Rockwell service letter No. SL-AG-74A

Service Letter No. SL-AG-74A
(Supersedes Service Letter No. SL-AG-74)
October 24, 1975

MASTER RELAY CONTROL CIRCUIT

MODELS AFFECTED: MODEL S-2R, SERIAL NO'S 1640R THRU 2173R AND 5001R THRU 5075R.

Figure 1.

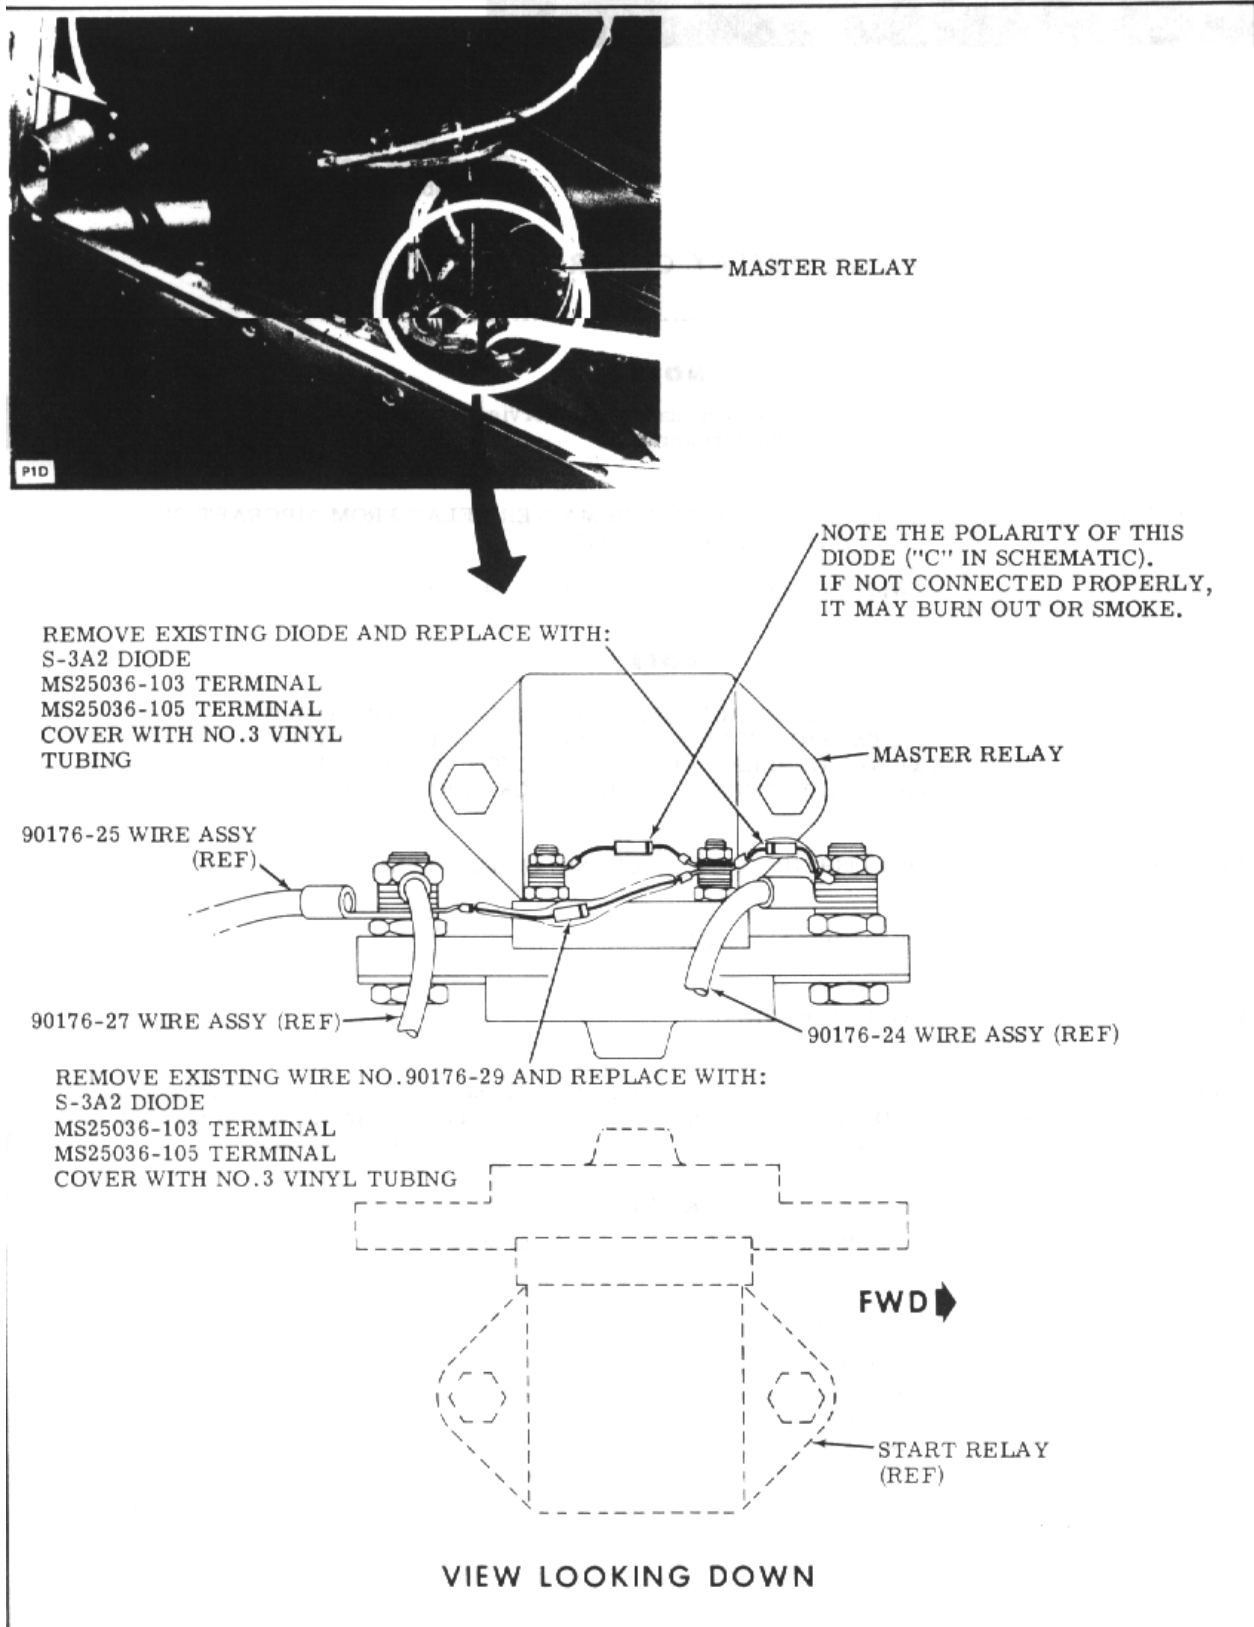
1. Assure that battery switch is OFF.
2. Remove right fuselage skin below cockpit to gain access to battery.
3. Disconnect battery.
4. Remove and discard wire No. 90176-29, and existing diode from master relay (see Figure 1.).
5. Install S-3A2 diode (2 places), MS25036-103 terminal (2 places), MS 25036-105 terminal (2 places), and No. 3 vinyl tubing (see Figures 1. And 2.).
6. Reconnect battery.
7. Reinstall fuselage skin.

1. In case of conflict between illustration and installation shown in Figure 1., and this schematic, follow the schematic.
2. Wire numbers shown are for guidance only and may vary in different airplanes.

3. In all cases follow the schematic to check the connections from positive of battery to relay contact terminal (large stud) and External Power connection to relay contact terminal (large stud). Other side of relay contact (large stud) is output of Battery Power and External Power. Coil terminal of the relay which accepts positive voltage from Battery and/or External Power. Coil terminal of relay which is connected to Battery switch.

4. Delete diode "B" from airplane.
5. Install new S-3A2 diodes "B" and "A" as shown in schematic (read step 3. above).
6. Diode "C" may or may not be installed in the airplane. This diode may be installed if required to suppress minor noise or voltage spikes.
